PLANAPP 2025-01327: 3709 Barrington Street Team Review Response

Comment Responses - Transportation Impact Review:

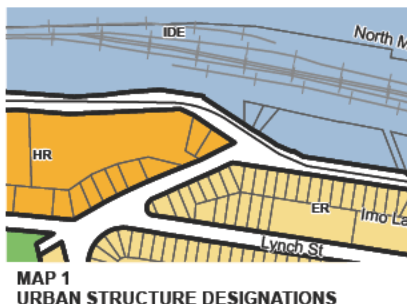
The HDI and CLI zones share the same Industrial Employment Designation in the Generalized Future Land Use Map and may be rezoned following Policy IM-6 of the RSMPS (a) which sets out that “Council may consider amendments to the zoning boundary schedule of the Regional Centre Land Use By-law that carry out the intent of this Plan and:

a) rezone the land to another zone enabled within the same designation as the land is

located, provided that the lands are located within the ... Industrial Employment Designations"
